SUBJECT: Forwards Amend 5 to FSAR, incorporating responses to NRC first round questions. FSAR Vol 17 A encl. *RGV 10/24/79 056*

Subject: WPPSS NUCLEAR PROJECT NO. 2
FSAR AMENDMENT NO. 5

The Washington Public Power Supply System herewith submits sixty (60) copies of Amendment 5 to its Final Safety Analysis Report. Amendment 5 incorporates the NRC questions/responses from Round One, Sets One through Four into the FSAR, plus other minor changes.

FIGURE
211.
031-1

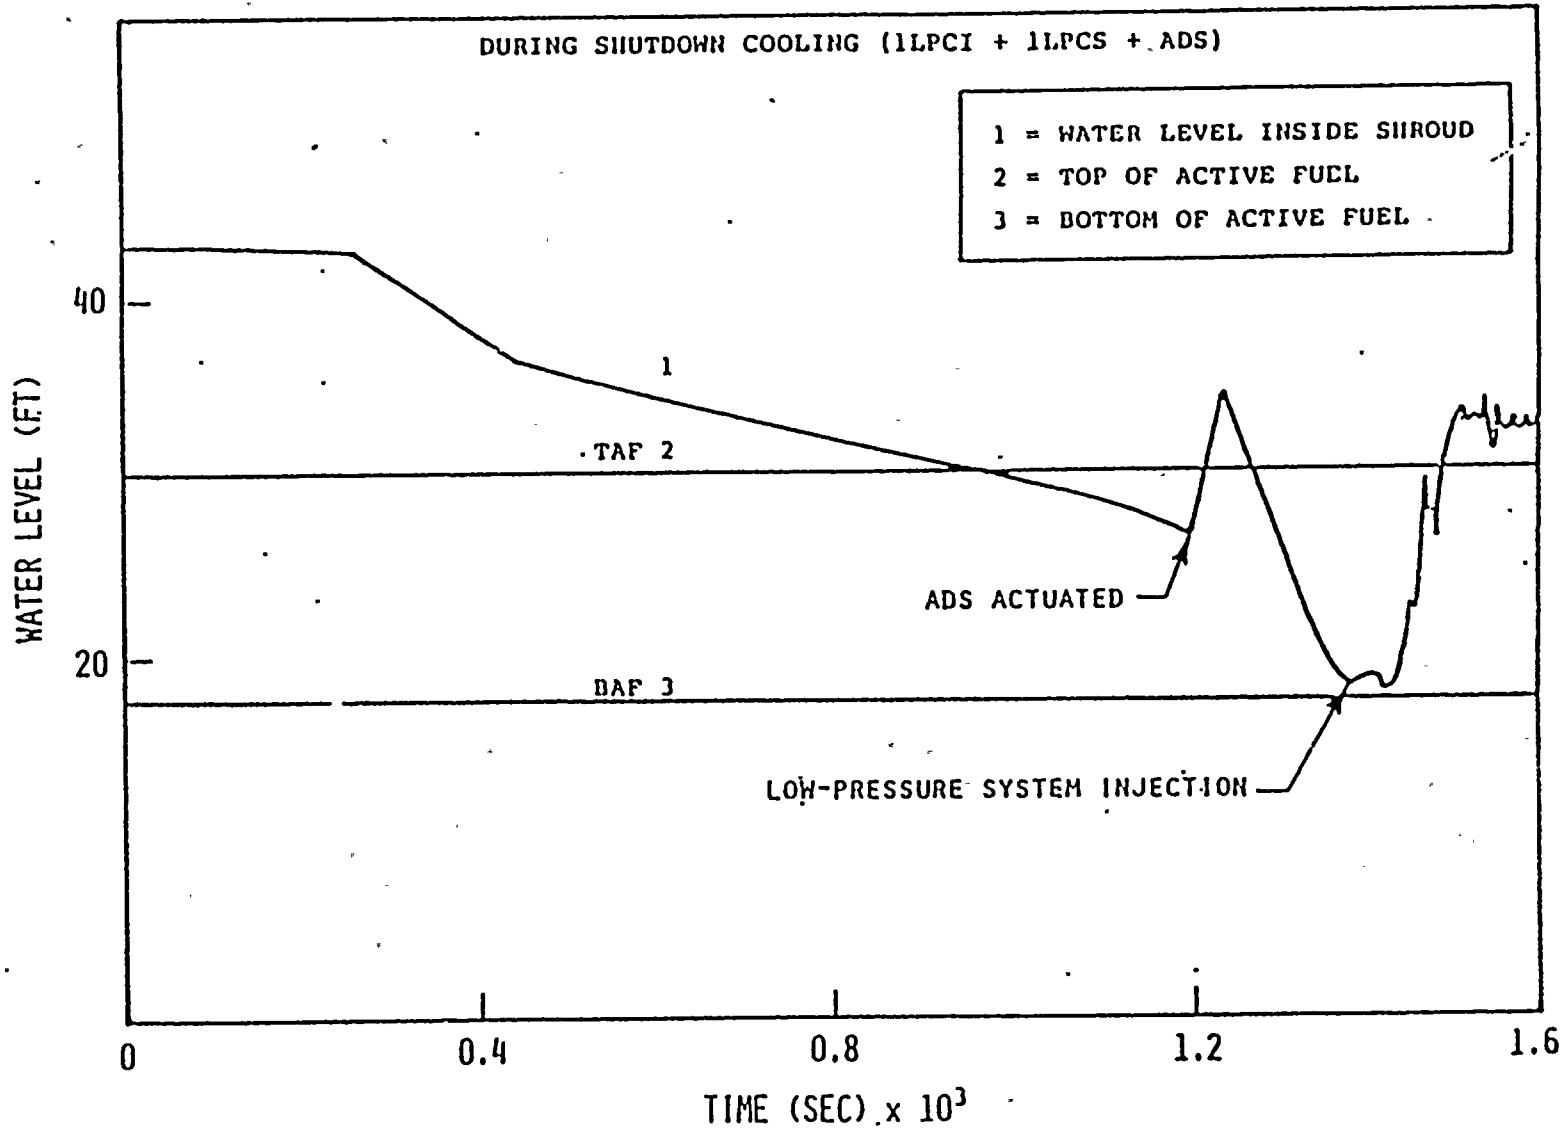
Pipe breaks in the RHR shutdown cooling mode which can affect other ECCS systems (LPCS, HPCS or RHRC) via flooding through the floor drain piping in the upper portions of the reactor building will have flooding rates less than 1000 gpm because they will be higher in the building (less static head), have less driving head due to friction losses, and smaller crack sizes (smaller

diameter pipe). These pipe breaks in the upper portion of the reactor building will be immediately detected by the high flow (5 gpm) alarms in the floor drain downcomer piping. Regardless of what the pipe break discharge rate is, the flood level resulting from 13,000 gallons is not capable of affecting the operation of the LPCS, HPCS or RHRC pumps, assuming all of the water is spilled into each pump room. Again, no operator action is required to protect these pumps.

It should be noted that the environmental effects (pressure, temperature and humidity) of pipe breaks during shutdown cooling are being addressed by ongoing pipe break and missile study. ^{the}

PLAN PENETRATIONS X-32 & X-35
SCALE: 1/16" = 1'-0"

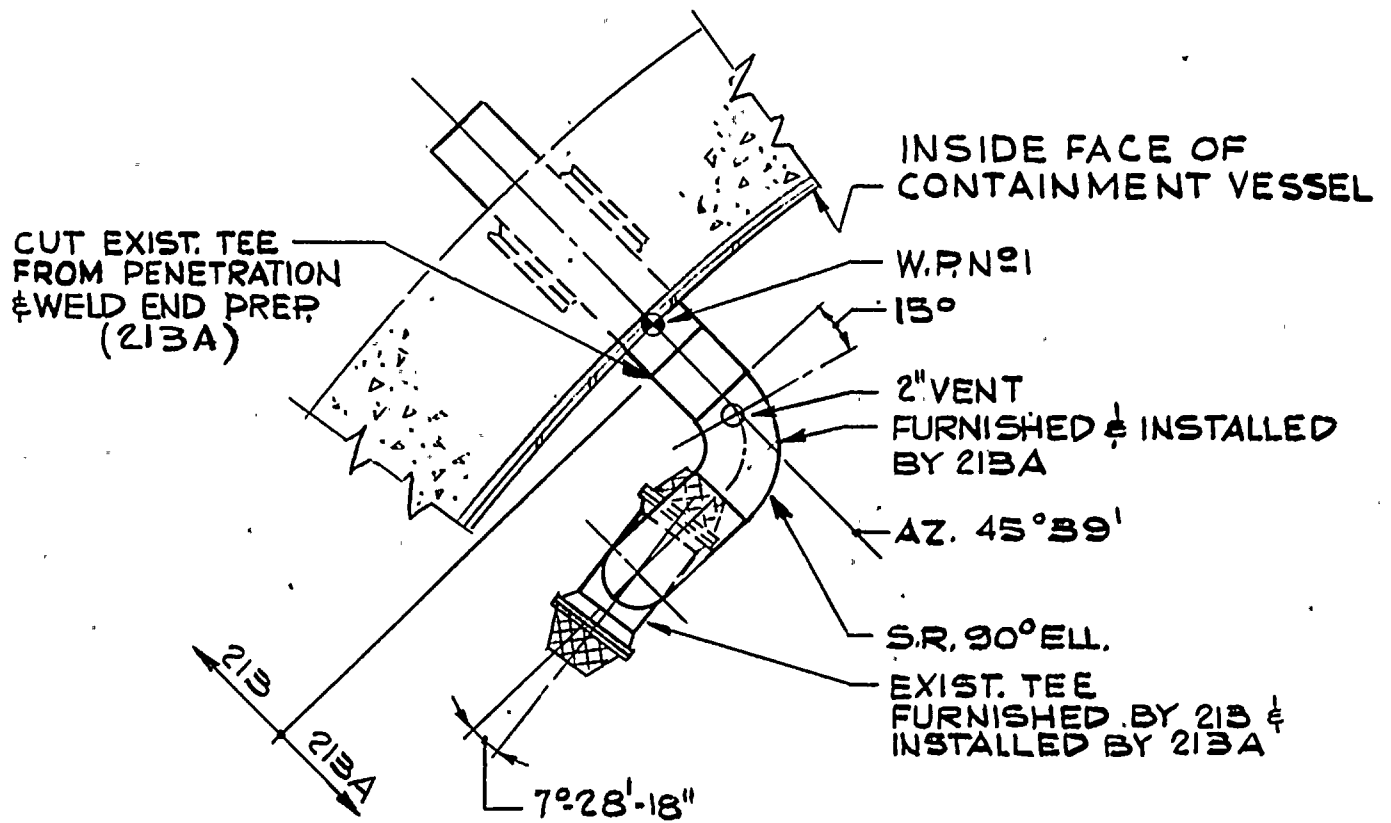
Provide a more detailed description, including the location, of the RHR pump suction strainer which is inside the suppression pool. Indicate the pipe beds and the minimum height of the suppression pool water level above this strainer. Show that the required net positive suction head (NPSH) at the centerline of the RHR pump will be available when the pump is operating at its design conditions and at the most limiting operating conditions. Discuss the size of particles that could pass through the strainer into the RHR pump passages. Indicate the amount of material blockage it would take to significantly reduce the RHR pump suction flow from the suppression pool following a postulated LOCA.

The suction strainers have been purchased to new criteria as defined by the Mark II Hydrodynamic Load Program. The specifications for the strainer were provided in the response to Question 022.039. The location of the suction strainers inside the suppression pool, as well as the pipe bends, are shown on Figures 211.033-1 and 211.033-2. Outside the suppression pool, RHR A and B loops have five elbows and RHR C has six elbows.

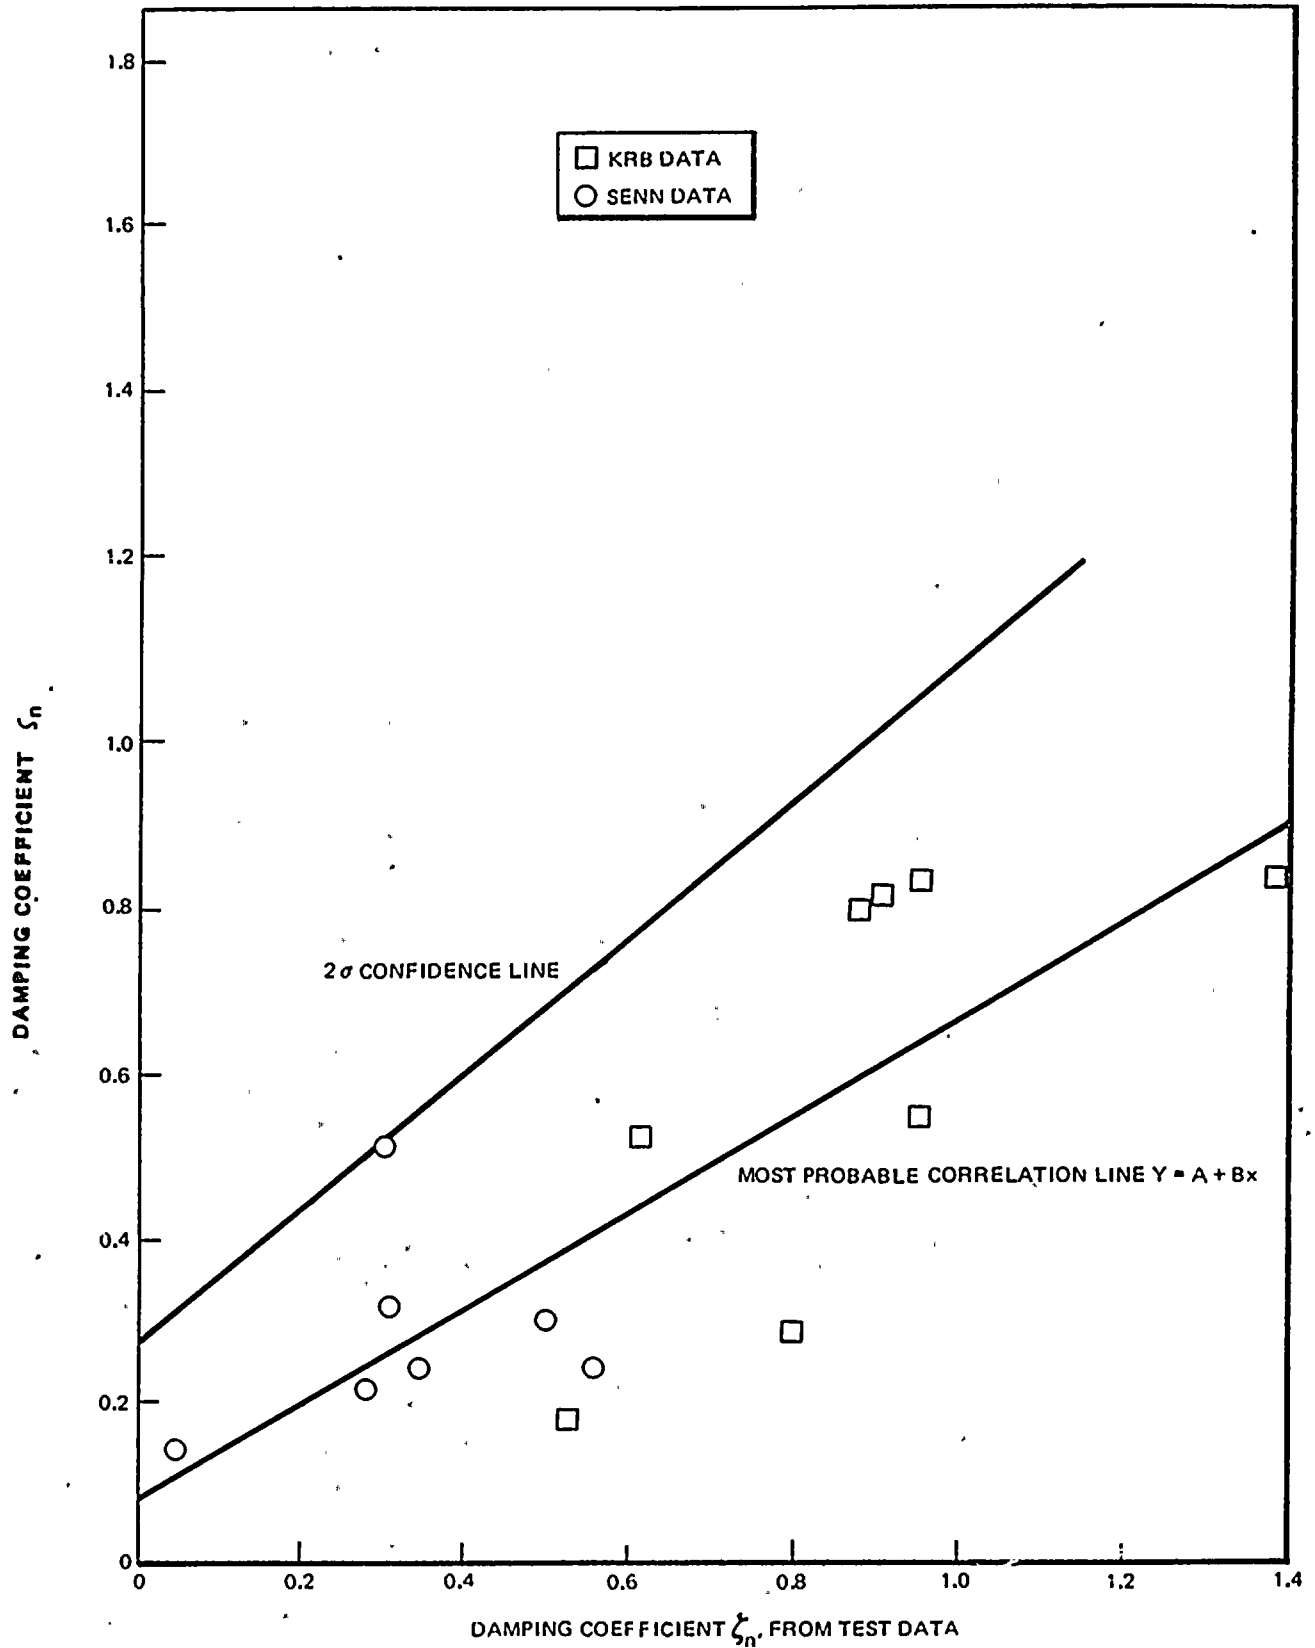
In 4.4.4.6 of the FSAR, you state that as new experimental or reactor operating data are obtained, the analytical model is refined to improve its capability and accuracy. This implies that a comparison of older versions of the model with test data, as shown in Figure 4.4-4, are meaningless for the WNP-2 facility if it has been analyzed with an updated version. Indicate whether the comparisons of the analytical model with the test data, as given in Figure 4.4-4, are based on the same version of the model as was used for the WNP-2 facility. If not, provide comparisons using the present WNP-2 model. In addition, provide a description of the code. While you may reference a submittal on another docket, references to KAPL reports on the code, STABLE, are unacceptable.

The amended 4.4.4 no longer contains Figure 4.4-4. Figure 4.4-4 is attached as part of this response (Figure 221.010-1).
